**City of Fairhope
Planning Commission Agenda
5:00 PM
Council Chambers
June 4, 2018**

Case: SD 18.07

Resubdivision of Lot 4, East Fairhope Plaza

FINAL SUBDIVISION PLAT

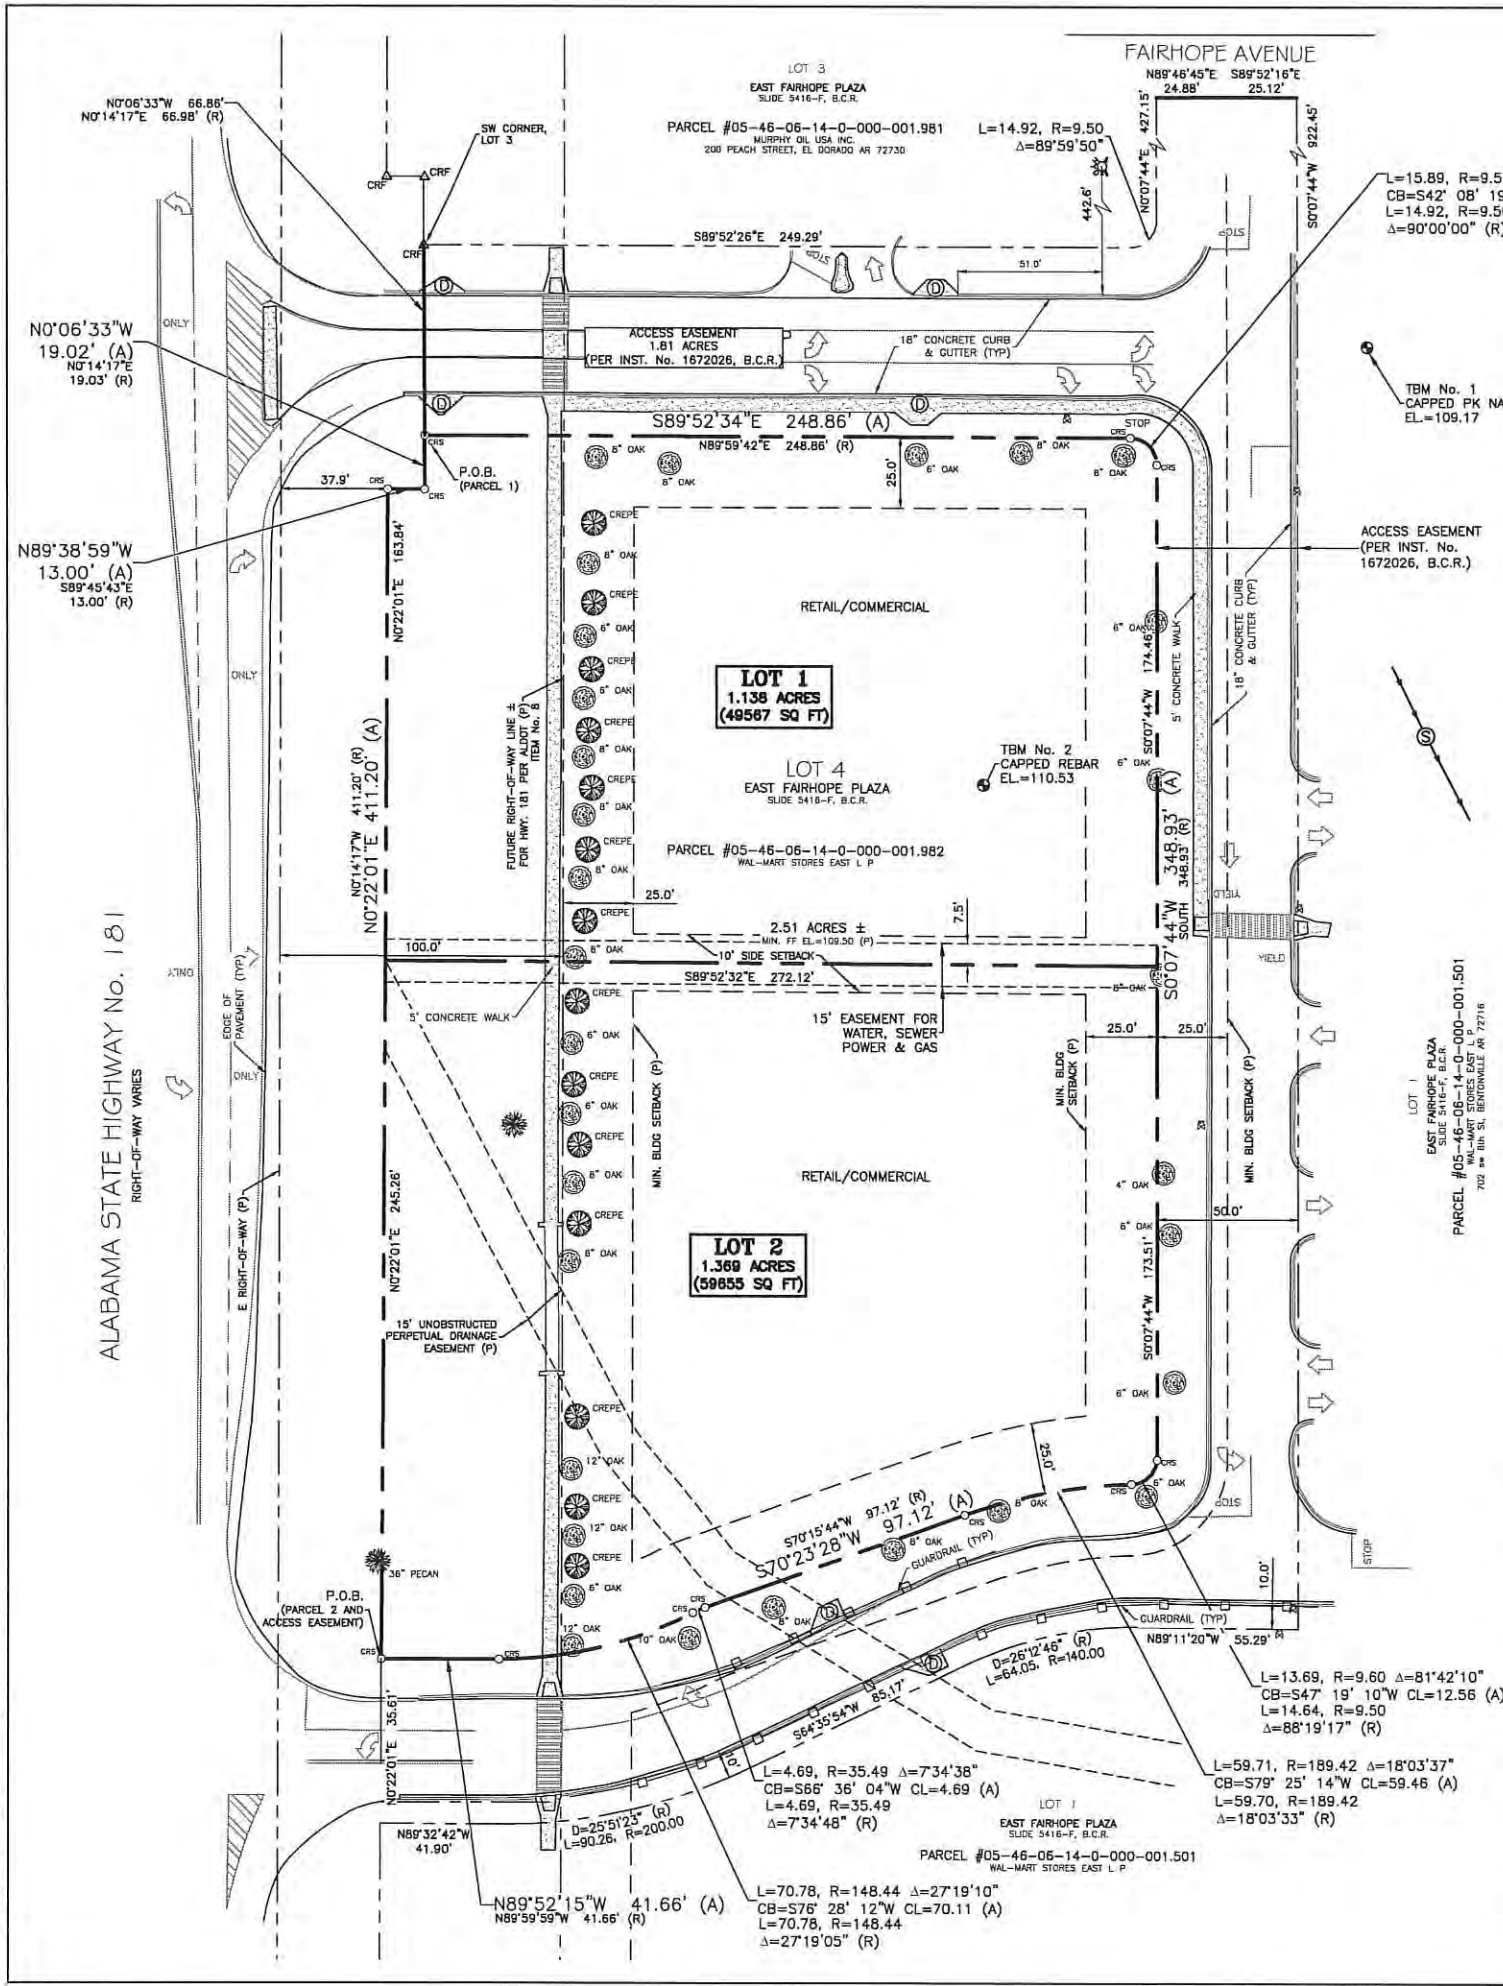
Comments: *Utility access easements are not shown or noted on the plat. See conditions of approval. The 15' drainage and utility easement is shown on lot line dividing lots 1 and 2, but not shown on the northern side lot line of lot 1 and the southern lot line of lot 2, and not depicted on the rear lot lines of lots 1 and 2.*

Comments: *Please see Article IV, Section C.1.b.(11) Flow model data for more information related to the fire hydrant and fire flow model for subject property. See conditions of approval. The fire hydrant shown on the plat is located along CR 48 near the existing medical facility and did not receive a flow model. Further, this hydrant is more than 450' from subject property and as a result a new hydrant must be installed to service the new subdivision. The submitted flow model is of a hydrant located near the intersection of HWY 181 and Margaret Drive, more than 1,000 feet away, also not in compliance with this section.*

<input type="checkbox"/> N/A	<input type="checkbox"/> Accepted	<input checked="" type="checkbox"/> Revise and Resubmit per comments
Cross Reference: <i>Standard Specifications for Constructing Sanitary Sewer Facilities and Water Facilities</i>		
Comments: <i>Comments: See Article IV, Section C.1.b.(8) Plan and profiles of all proposed utilities with connections for correspondence with the Utilities Director of Operations regarding availability of Fairhope Public Utilities. Also, please see the photos and comments included in the cover letter associated with this checklist. See conditions of approval. Standard Specifications for Constructing Sanitary Sewer Facilities and Water Facilities not included in application. As stated in the comments related to Article IV, Section C.1.b.(11) the fire hydrant tested for the site is too far away to satisfy the fire protection requirements of the site.</i>

- i. Indicate the location of the new fire hydrant on the preliminary plat as required by Article VI, Section G and provide plans and profiles of the new main servicing the new hydrant.

- d. Article IV, Section C.5. Pre-Construction Conference
 - e. Article V, Section E.5.a.- c. Indicate the 15’ drainage and utility easements on the northern lot line of lot 1 and the southern lot line of lot 2, as well as rear lot lines of lots 1 and 2.

- i. Correctly reflect the drainage and utility easements described above on Plan Note number “7” on the preliminary plat.
 - ii. Edit the “narrative” on the preliminary plat to reflect a “major” subdivision in lieu of a minor subdivision.

PERMIT DRAWING

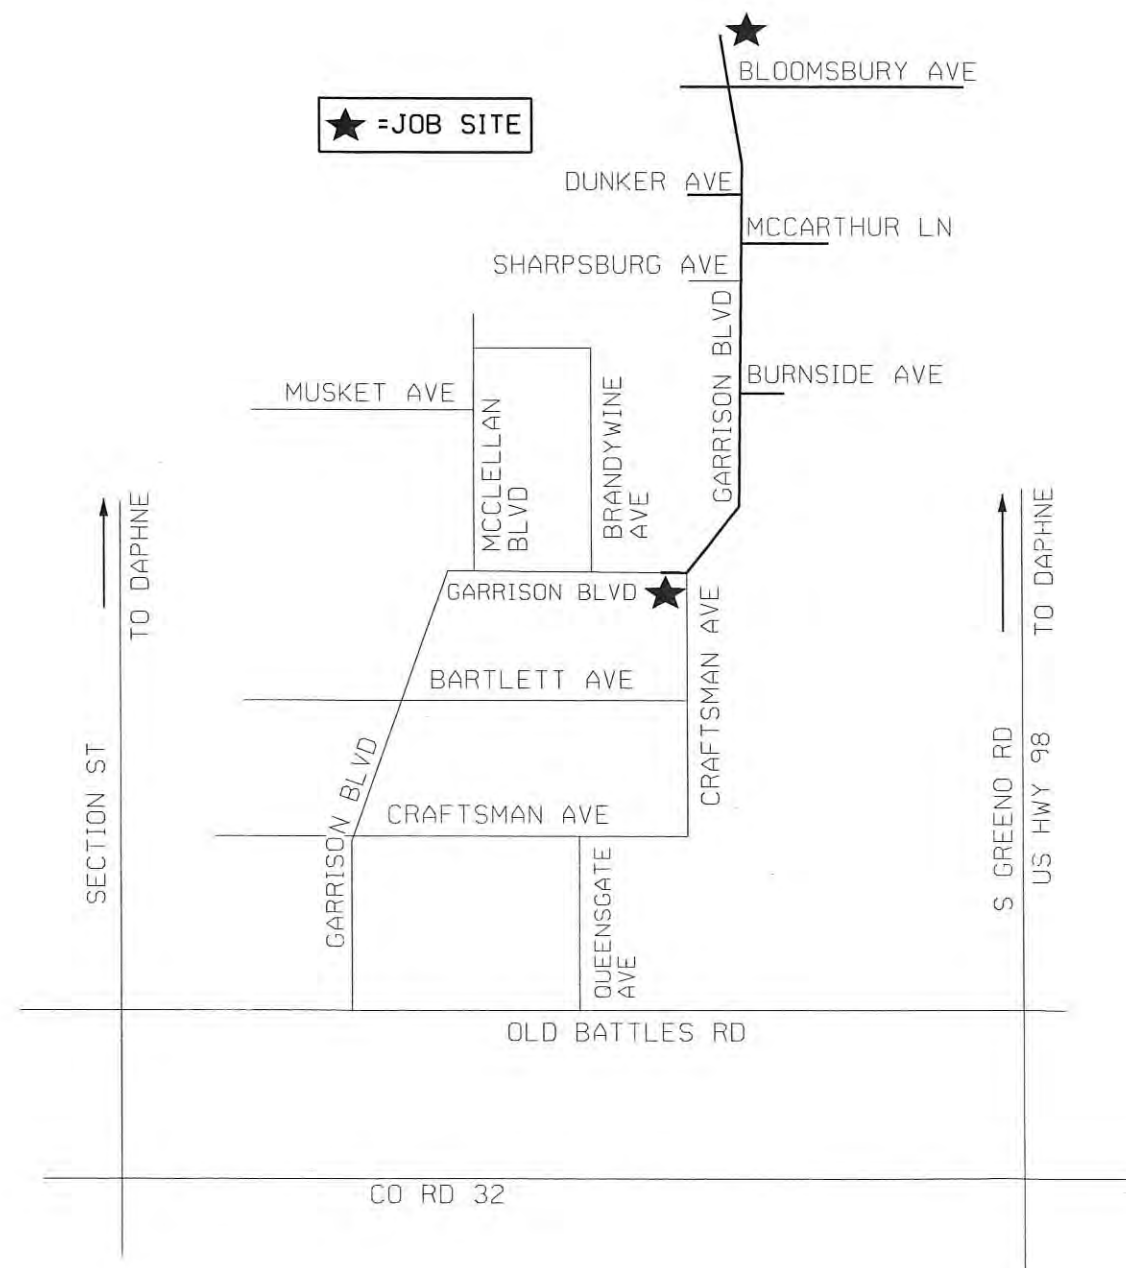
- a. Drawing 2 of 11 revise the conduit separation from 26" to 36"
 - b. Drawing 10 of 11 revise the Bloomsbury Avenue detail from 32" to 36" conduit separation

- c. Drawing 10 of 11 revise the Garrison BLVD detail from 24" to 36" conduit separation
